Access Compliance Report Public Rights-of-Way (Curb Ramps)

Main Street: BULLARD_RD Cross Street: BULLARD_RD Location: NE

ADA ID: RPRK220103150014 Ramp Type: Type 1 - Perpendicular Diagonal Initial Pass/Fail: Pass Overall Compliance: No Severity Score: 0

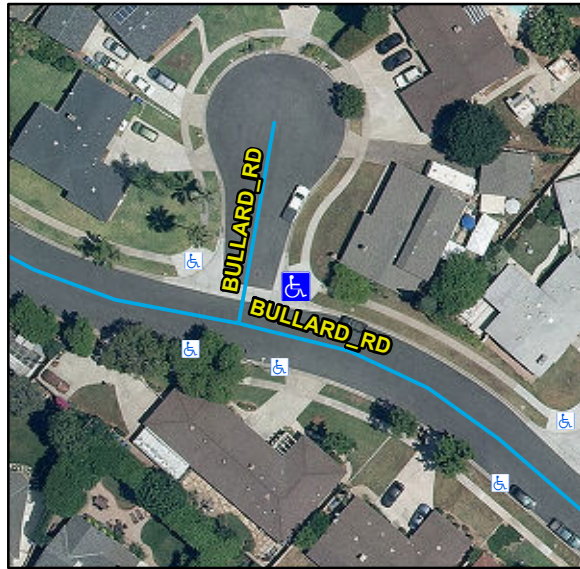
Compliance	Description	Data	Compliance	Description	Data
N/A	Ramp Length (in)	83	N/A	Flare Type LT	
Yes	Ramp Width (in)	48			Sloped
Yes	Ramp Run Slope (%)	7	N/A	Flare Slope LT (%)	6
Yes	Ramp Cross Slope (%)	0.4	N/A	Flare Traversable LT	No
N/A	Landing Present	Yes	N/A	Flare Type RT	
N/A	Landing Length (in)	49			Sloped
Yes	Landing Width (in)	48	N/A	Flare Slope RT (%)	5.6
Yes	Landing Run Slope (%)	1.9	N/A	Flare Traversable RT	No
Yes	Landing Cross Slope (%)	0.1	Yes	DWS Provided	Yes
N/A	Landing Movement Obstructed?	Yes	Yes	DWS Contrast	Yes
	Landing Movement Type	Curb	Yes	DWS Length (in)	36
N/A	Landing Shared	No	Yes	DWS Full Width	Yes
N/A	Clear Space	Yes	Yes	DWS Offset Left (in)	2
N/A	Clear Space To Crosswalk (in)	48	Yes	DWS Offset Right (in)	N/A
N/A	Marked Crosswalk 1	No	N/A	Marked Crosswalk 2	No
	Crossing 1 Direction	W		Crossing 2 Direction	S
	Marked Crosswalk 1 Width (in)	N/A		Marked Crosswalk 2 Width (in)	N/A

N/A	Ramp Inside Crosswalk 1	N/A	Yes	Ramp Inside Crosswalk 2	N/A
	Crossing 1 Slope (%)	3.7		Crossing 2 Slope (%)	5.3
	Crossing 1 Cross Slope (%)	1.7		Crossing 2 Cross Slope (%)	1.2
Yes	Gutter Ponding	No	No	Curb Slope	6.3
Yes	Gutter Lip Height (in)	0		Road Run Slope (%)	0.5
Yes	Gutter Run Slope (%)	0.4		Road Cross Slope (%)	2.3
Yes	Gutter Cross Slope (%)	0.2			
Yes	Overall Surface Condition: Acceptable		Yes	Perp Joint Present	Yes
	Cross Gutter Present?	Yes		Spandrel Present?	Yes
	Replace Cross Gutter?	No		Replace Spandrel?	No

Remove & Replace Curb Ramp With Two New Directional Ramps or Equivalent.
